Addendum #1 - Bid Package #6929-07

Project Name: Lincoln Public Schools District Office
5901 'O' Street
Lincoln, NE
Project No.: 11065
Issued: August 3, 2012

08/03/12
 SHEET
ME001
 ATTACHMENT NO.
E1
 B.J.F.

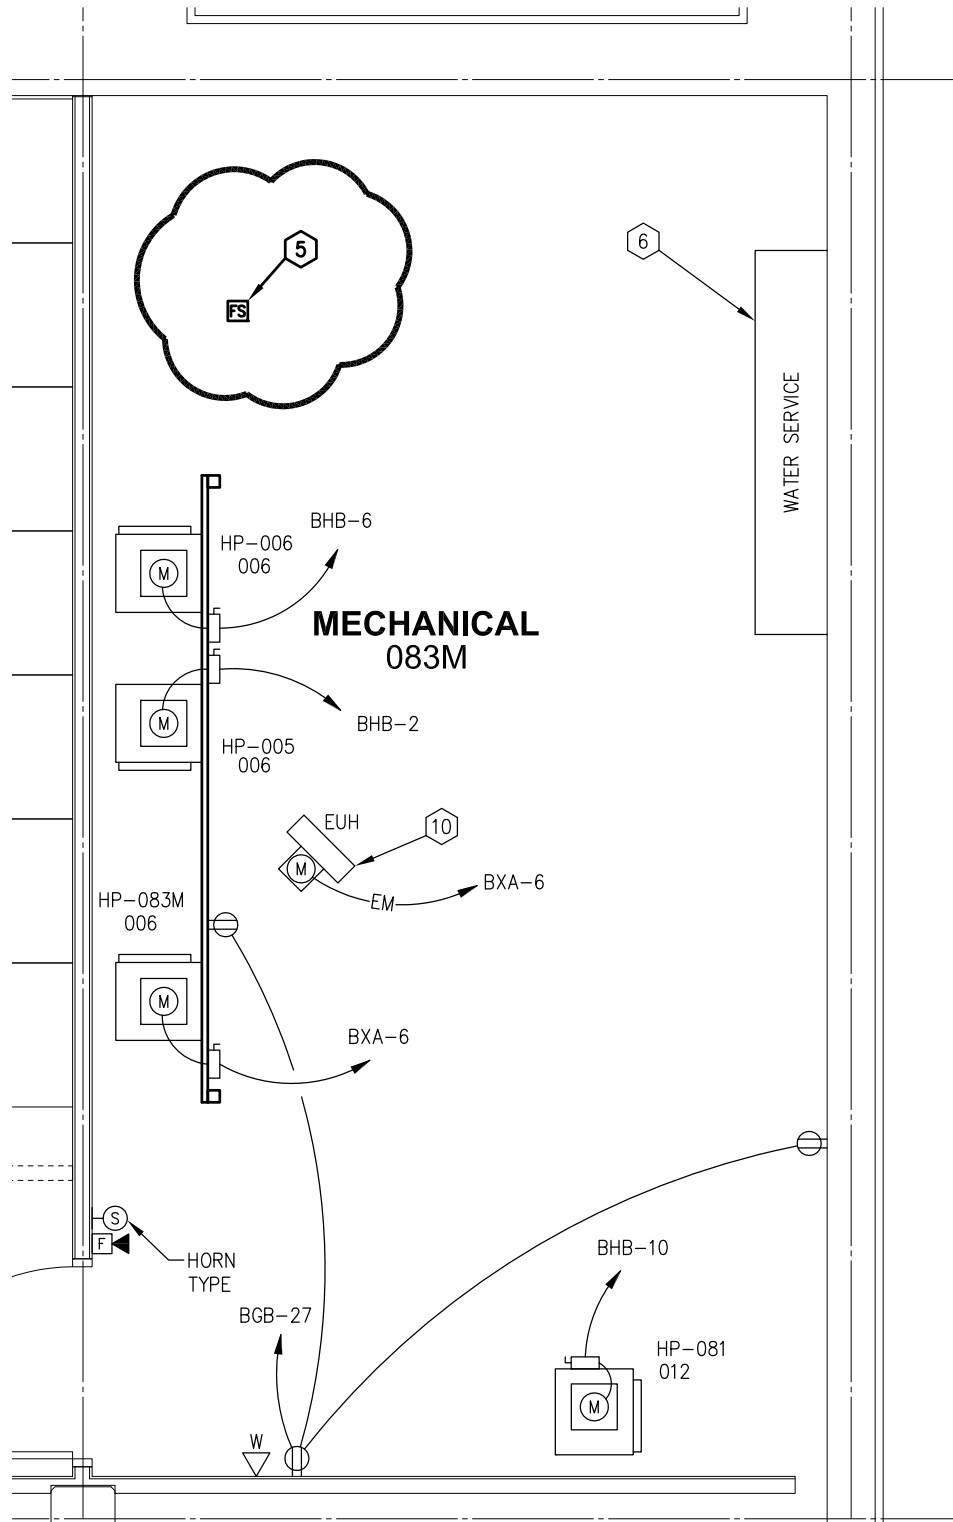
- ADD 1-22.** Refer to Sheet ME001 Mechanical/Electrical Site Plan
- A. LES will be furnishing two transformers to the site. Refer to **attached drawing E1**. Provide a concrete pad for each transformer and concrete filled protective bollards around transformers per LES specifications.

SHEET
E300

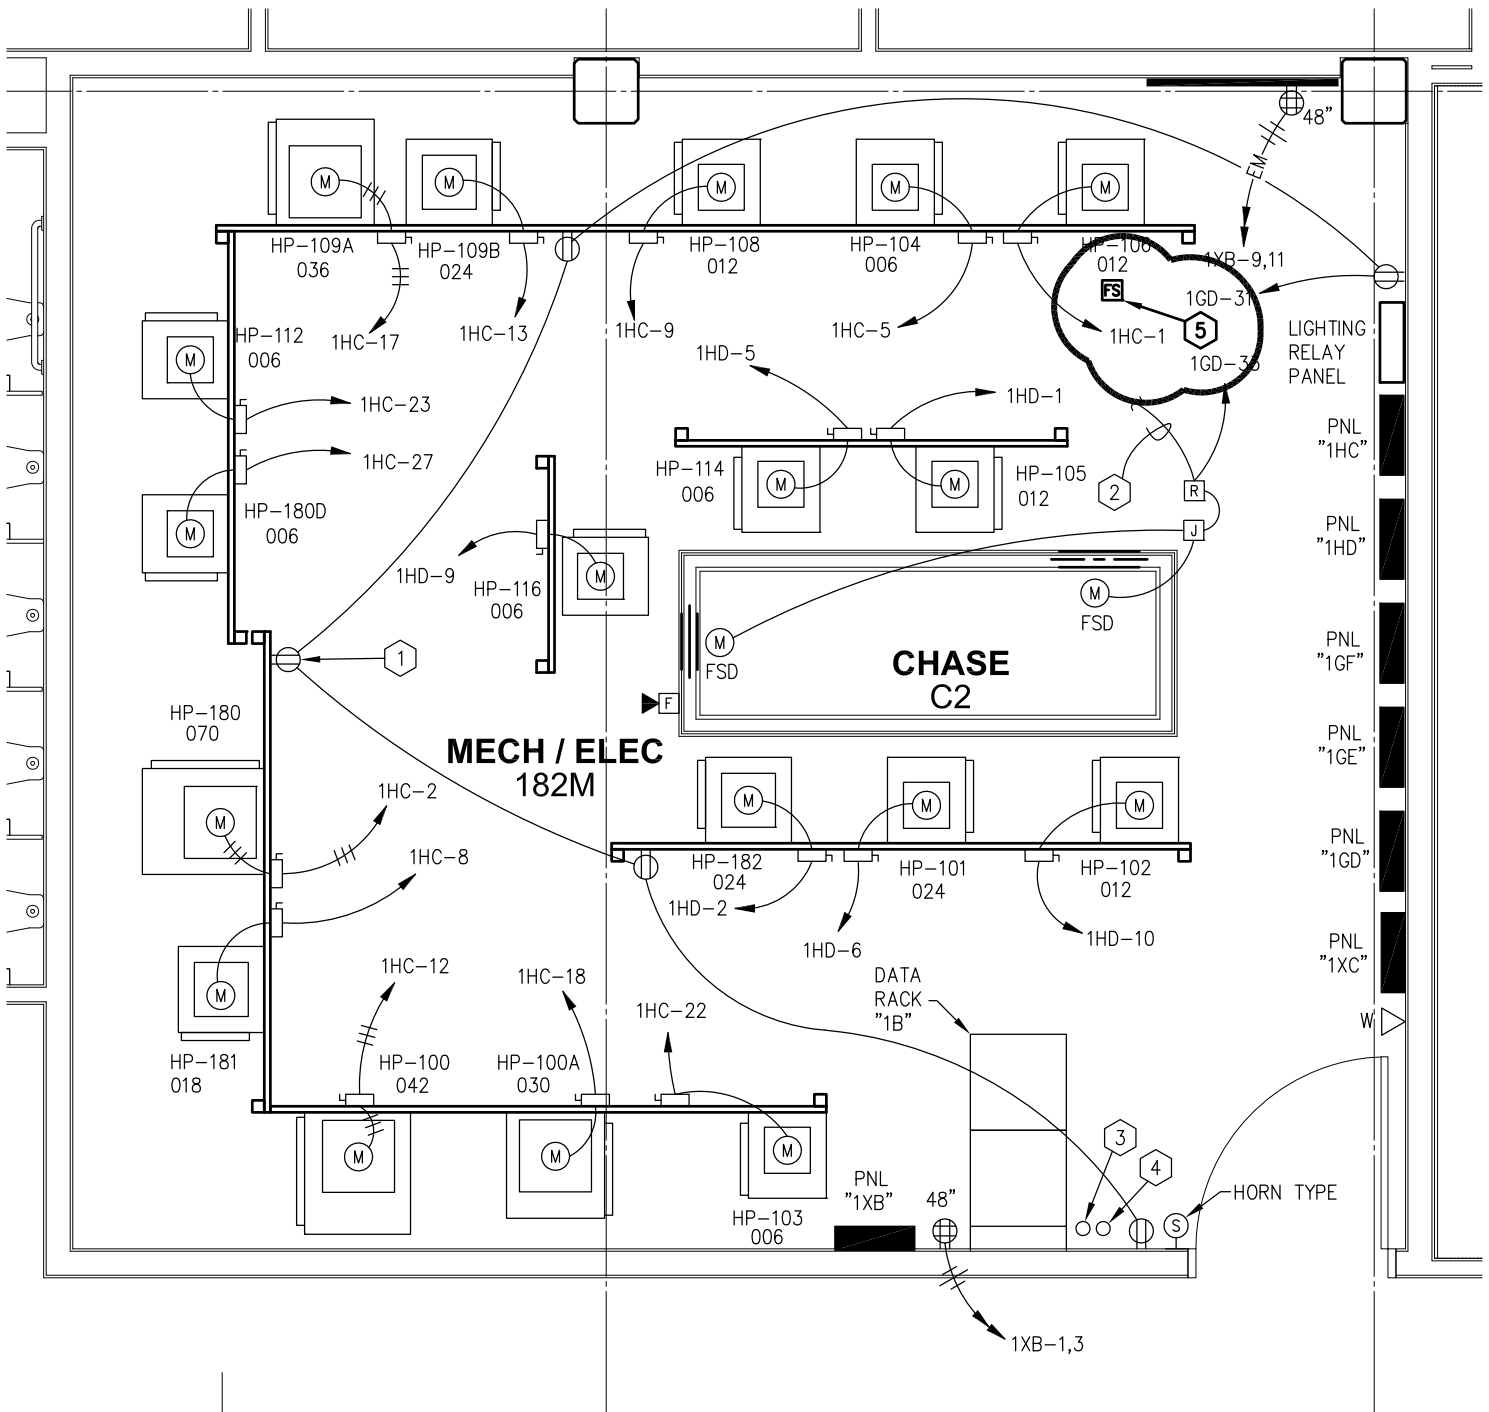
- ADD 1-24.** Refer to Sheet E300
- A. Data Center 084N – Provide a NEMA L6-30 receptacle and circuit next to the Fiber Rack. Connect to circuit BXA-24 and provide a 30A/2P circuit breaker in panel.

- B. Mechanical 083M – There will be only one fire sprinkler flow and tamper switch in this room.
- ADD 1-25.** Refer to Sheet E301

5. PROVIDE FIRE ALARM CONNECTION TO FLOW AND TAMPER SWITCH

E3

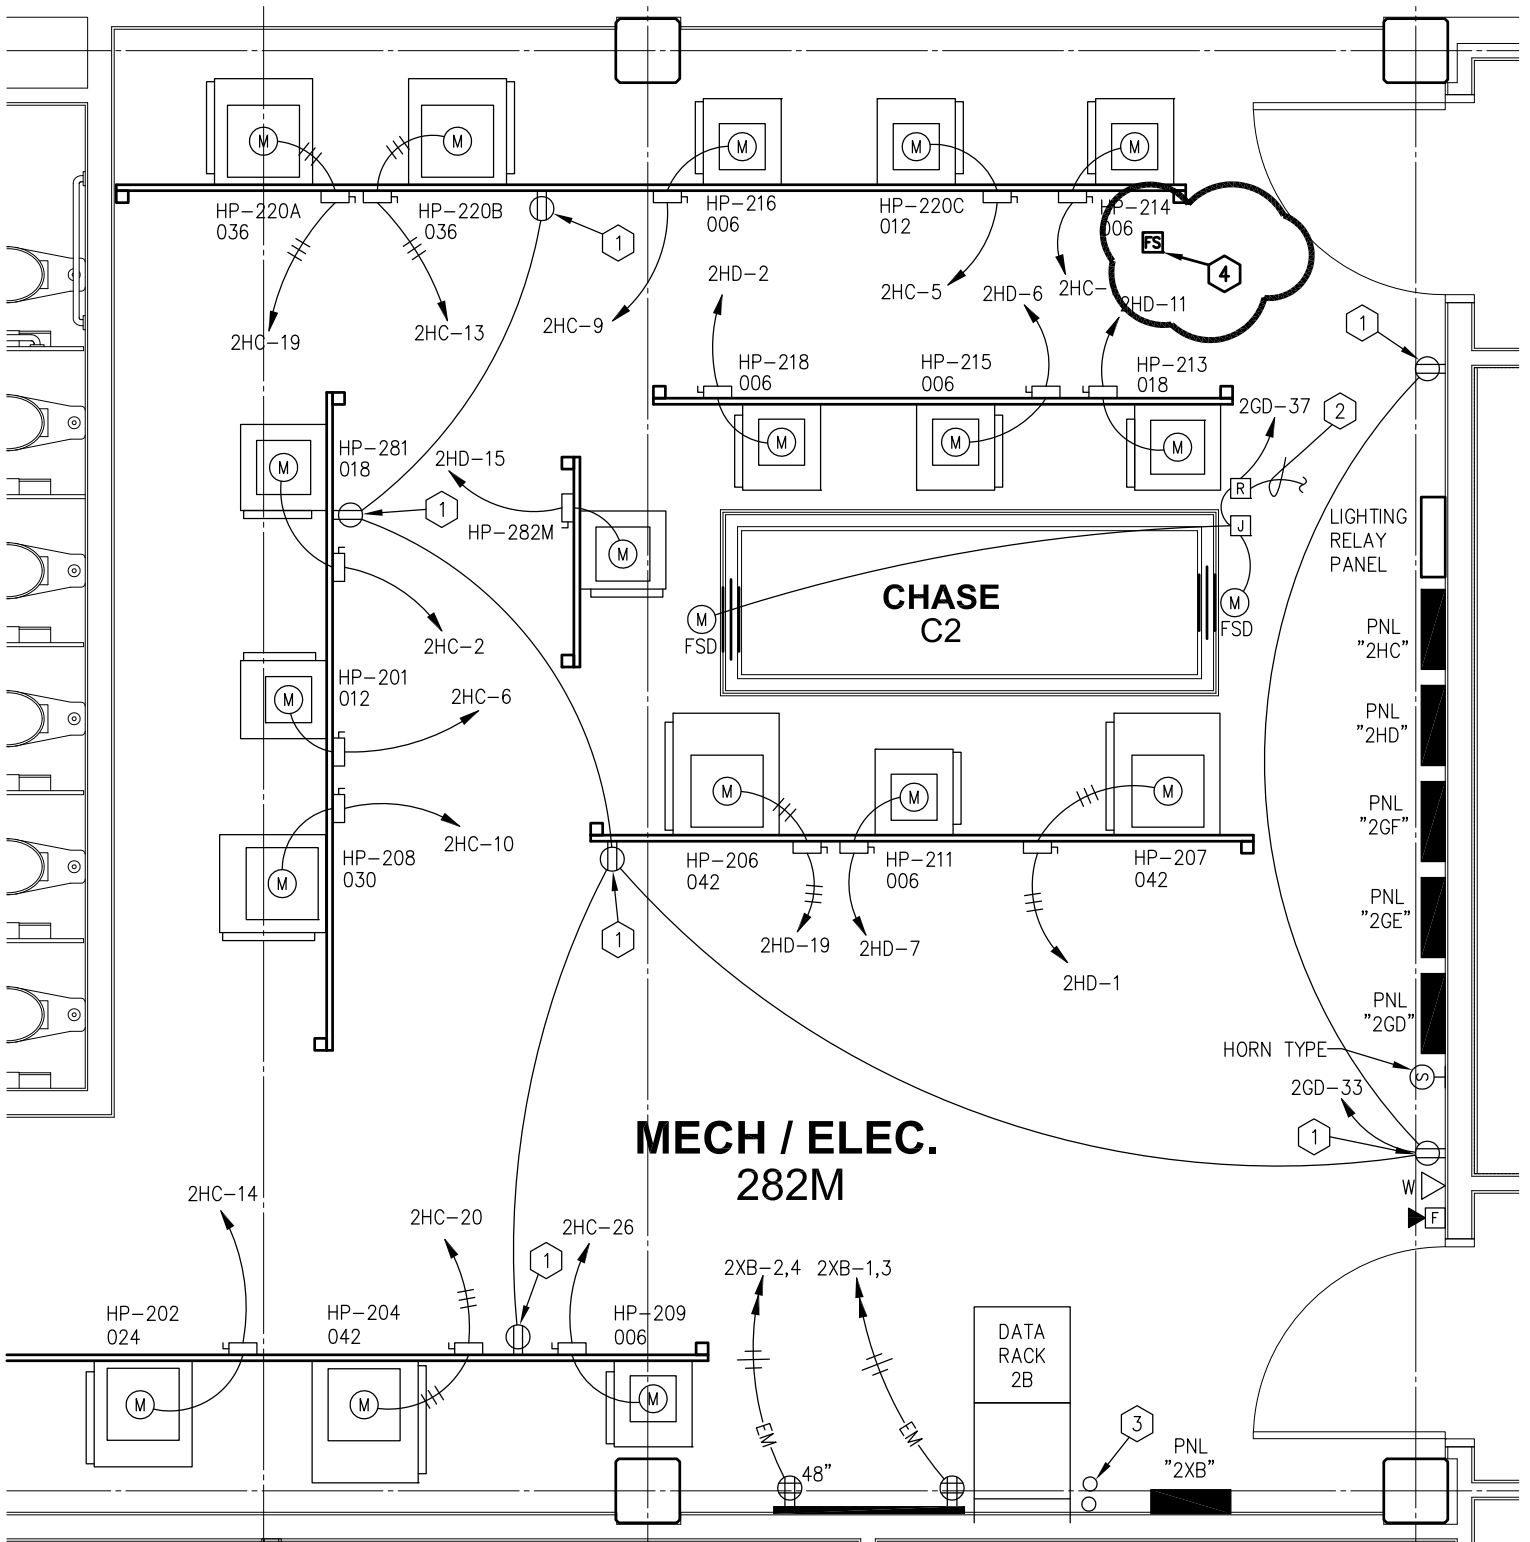
- A. Mech/Elec 184M – Provide a NEMA L6-30 receptacle and circuit next to the Data Rack 1A. Connect to circuit 1XA-16 and provide a 30A/2P circuit breaker in panel.
- B. Mech/Elec 182M – Provide a NEMA L6-30 receptacle and circuit next to the Data Rack 1B. Connect to circuit 1XB-6 and provide a 30A/2P circuit breaker in panel.
- C. Mech/Elec 182M – Provide fire alarm circuit to new fire sprinkler flow and tamper switches. See **attached drawing E3**.

4. PROVIDE FIRE ALARM CONNECTION TO FLOW AND TAMPER SWITCH

08/03/12
SHEET E300
ATTACHMENT NO. E4
BJF

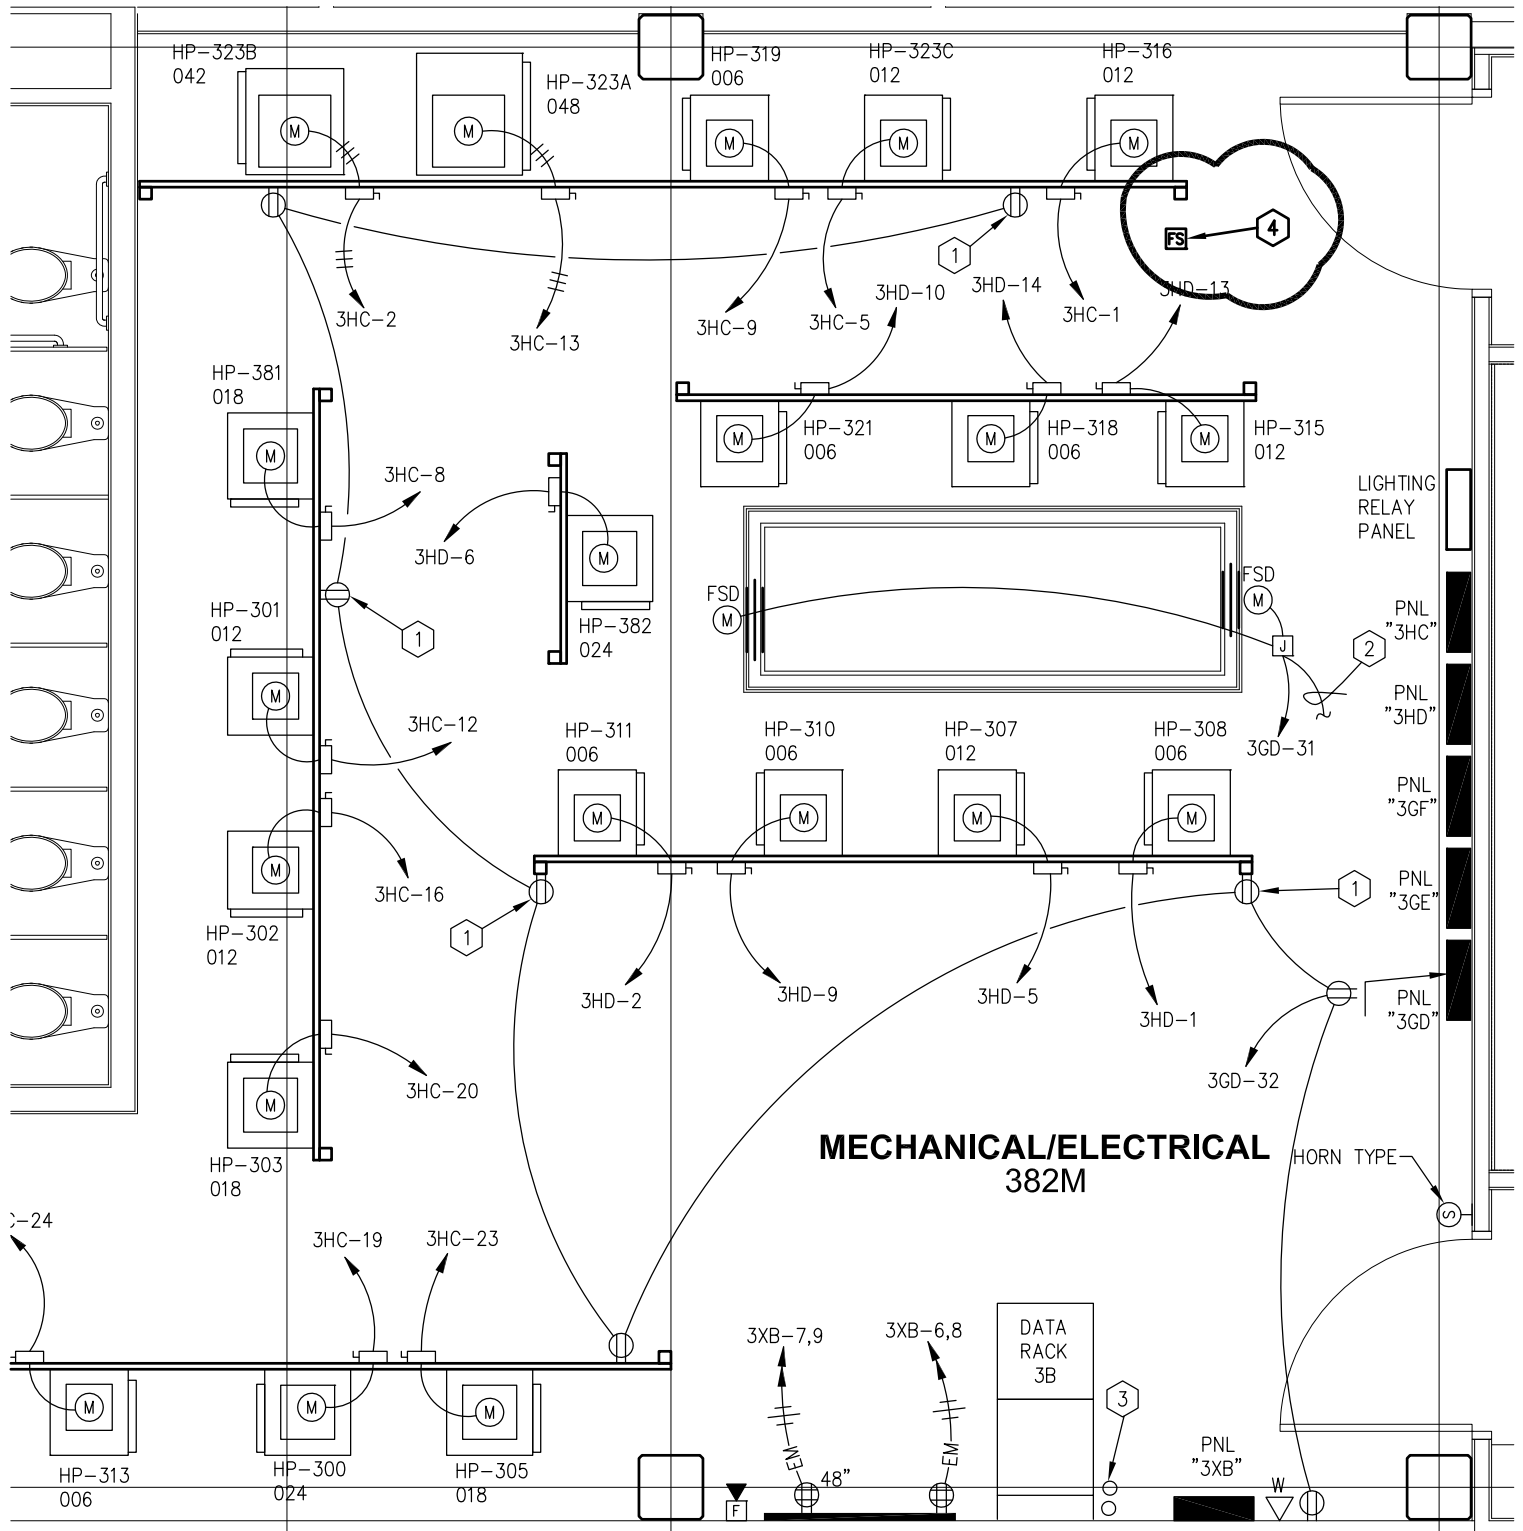
- A. Mech/Elec 284M – Provide a NEMA L6-30 receptacle and circuit next to the Data Rack 2A. Connect to circuit 2XA-9 and provide a 30A/2P circuit breaker in panel.
- B. Mech/Elec 282M – Provide a NEMA L6-30 receptacle and circuit next to the Data Rack 2B. Connect to circuit 2XB-5 and provide a 30A/2P circuit breaker in panel.
- C. Mech/Elec 282M – Provide fire alarm circuit to new fire sprinkler flow and tamper switches. See **attached drawing E4**.

4. PROVIDE FIRE ALARM CONNECTION TO FLOW AND TAMPER SWITCH
